REPORT TO PLANNING COMMISSION City of Sacramento

Subject: 7th & H Street SRO Mixed Use Project (P10-007) A request to construct an 8 story mixed use building, including 150 residential hotel units, ground floor health clinic, and a retail space, on 0.55 acres within the Central Business Special Planning District (C-3-SPD) zone.

REPORT TO DESIGN COMMISSION City of Sacramento

Subject: **625 H Street (DR10-033)** Located at the northwest corner of 7th and H Streets, a request to develop an eight story mid-rise 150 unit residential tower with ground floor retail and health clinic on 0.55+/- acres in the Central Business District Special Planning District (C-3-SPD) zone.

Exhibit D: Elevations

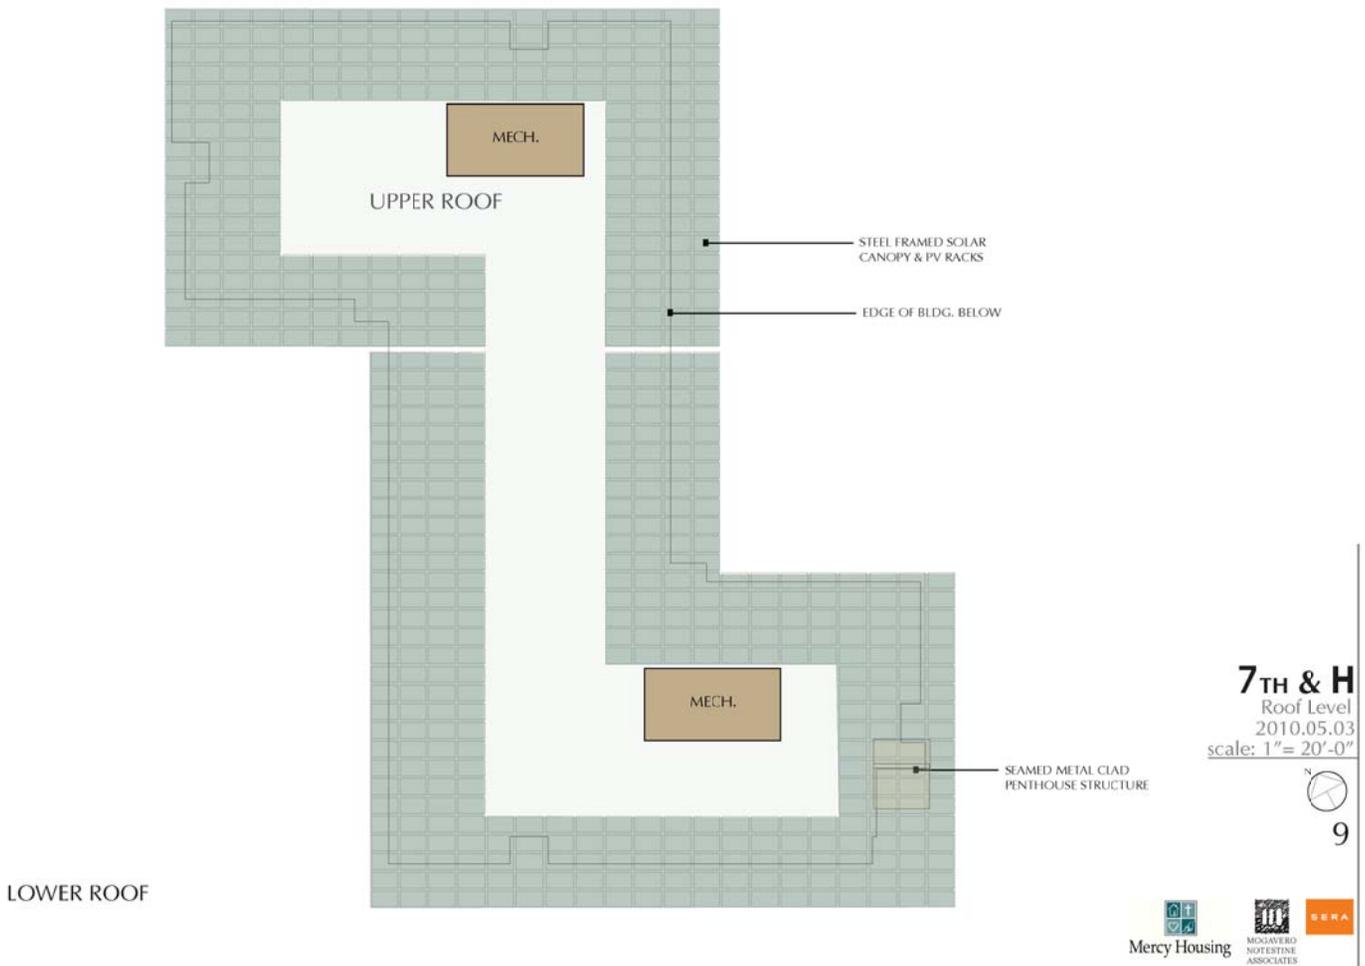
10. Aluminum louvered sunshades have been provided in select locations to assist with the passive solar design of the building. The same level of detail over the other windows has not been provided. The Design Team has provided a sketch DR 2 (Attachment 4, Page 32) that would integrate a course of inset dark brick to simulate the shadow line created by the awning. Staff feels that this inset brick coursing is a step in the right direction, but should be offset to create a similar shadow casting effect as the sunshades. Staff requests the Commission to comment on this item.

7. The prevalent views from I-5, Railyards, and general city skyline will require additional refinement/treatments of the building top and mechanical penthouses. Please provide revised plans incorporating the mechanical penthouse and the building top (cornice) as an integral part of the building regardless of the PV array as the proposed elements need further refinement and articulation.

Exhibit E: Landscaping Plan

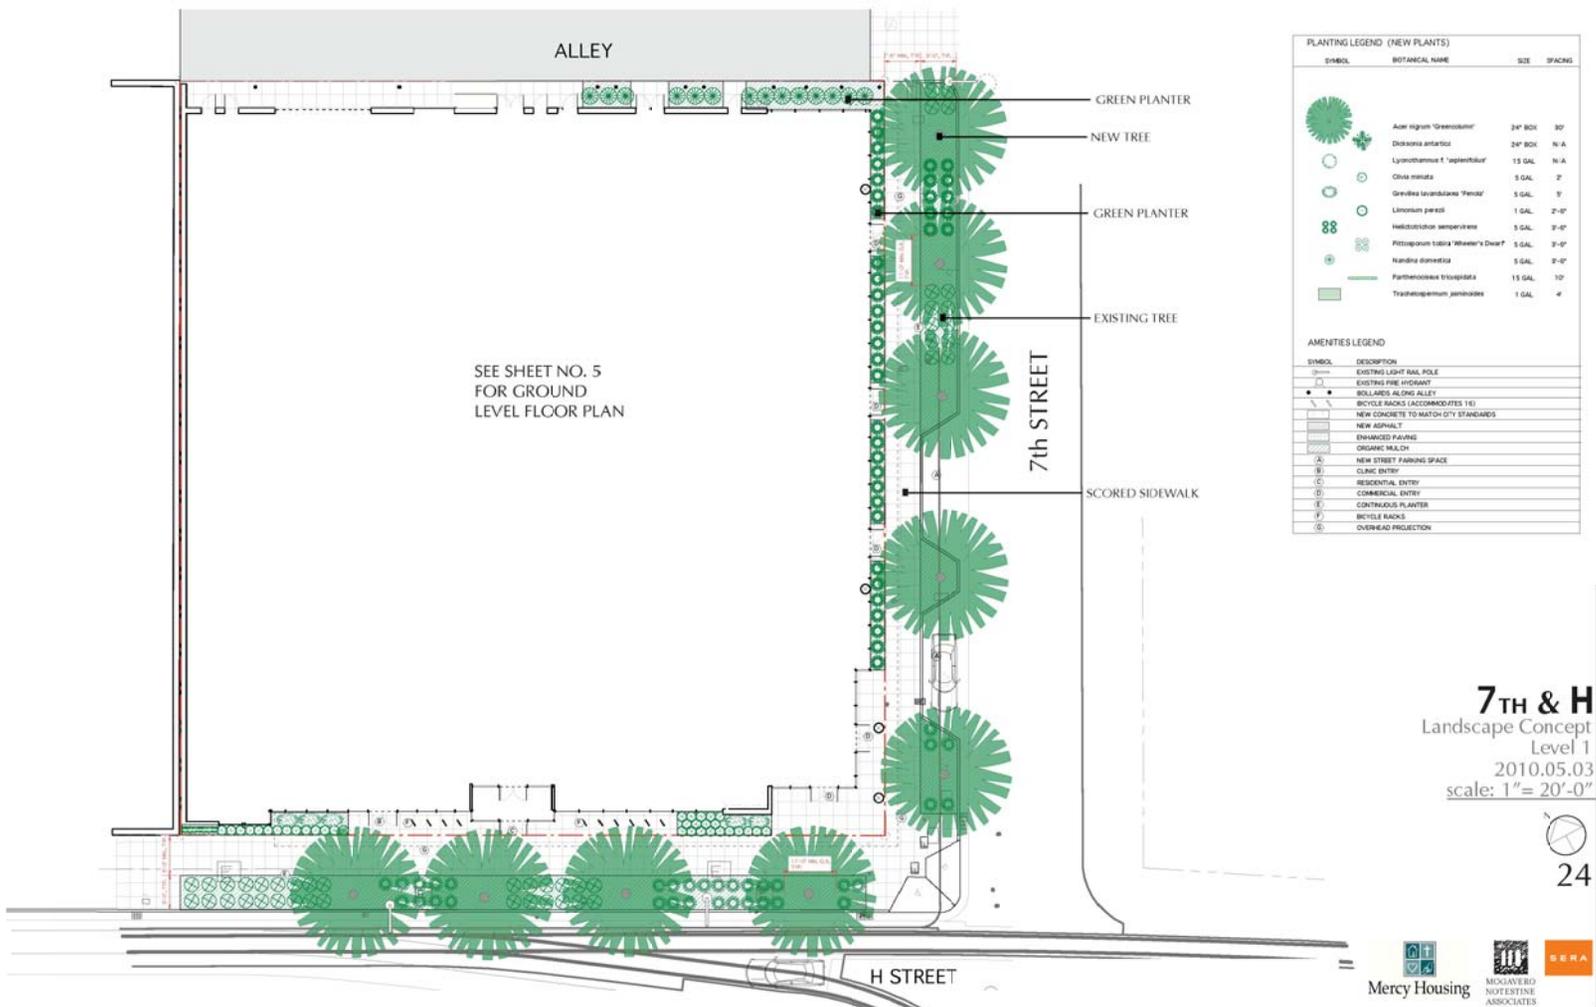
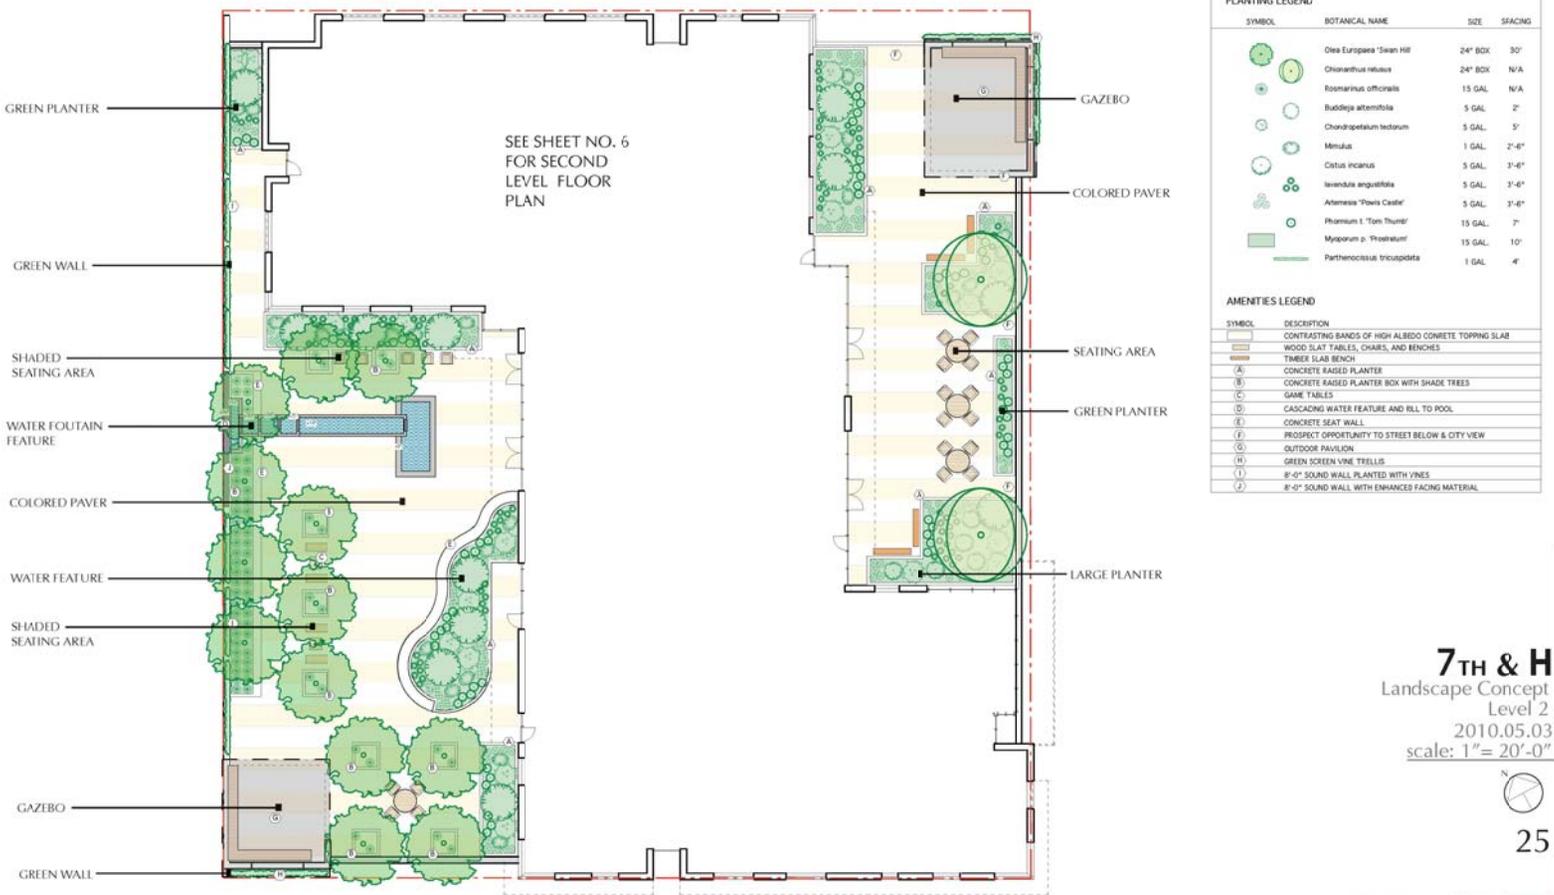
3. Landscaping has been provided along the 7th and H Streets Public Right of Way as well as along the building edges. Staff supports the design provided on the architectural plans, and recommends the applicant revise the landscape plans to match the proposed changes. Staff requests the Design Team to provide revised plans to the Design Commission and Staff prior to final action.

1. Plantings that are proposed at the terrace level seem better suited for wetter climates. The solar reflection of the building may impact these plantings and the amount of water that is required to support them. Please coordinate these comments on the plantings with the landscape architect prior to the next submittal. Also please confirm that there is enough soil volume for the green screen plantings.
